Subject: Waterford 3 SES  
Docket No. 50-382  
License No. NPF-38  
Operator Examination Comments

During the week of January 21, 2002, an NRC RO / SRO Examination was administered to eleven candidates at Waterford 3. As discussed with the examination team last week, we are hereby submitting comments (attached) associated with examination questions. The comments are being submitted per guidance in NUREG 1021, ES-402, Section E. This submittal does not contain any commitments.

Operator Examination Comments

## 10.2 BATCH PERMIT APPROVAL AND ACTUAL RELEASE

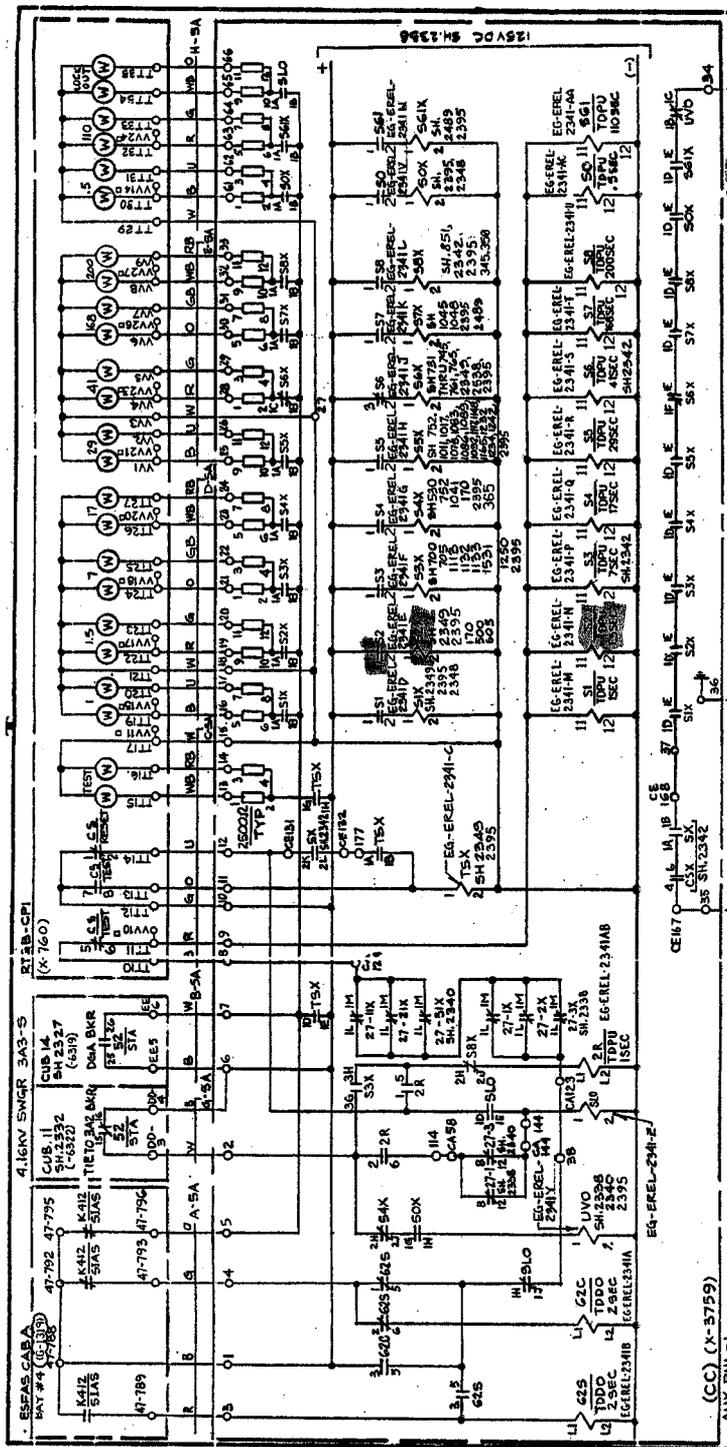
Per CE-003-515, Gaseous Radioactive Release Permit, page 14, the Note states that "Containment Purges releases during plant shutdowns will normally be accounted for on continuous permits following the initial Batch Release Permit period. Containment Purge may be re-started during plant shutdowns, with Chemistry Approval, without issuing additional Batch Release Permits." Therefore, Answer D is incorrect.

Containment Purge releases during plant shutdowns will normally be accounted for on continuous permits following the initial Batch Release Permit period. ~~Containment Purge may be initiated during plant shutdowns, with Chemistry approval, without issuing additional Batch Release Permits.~~
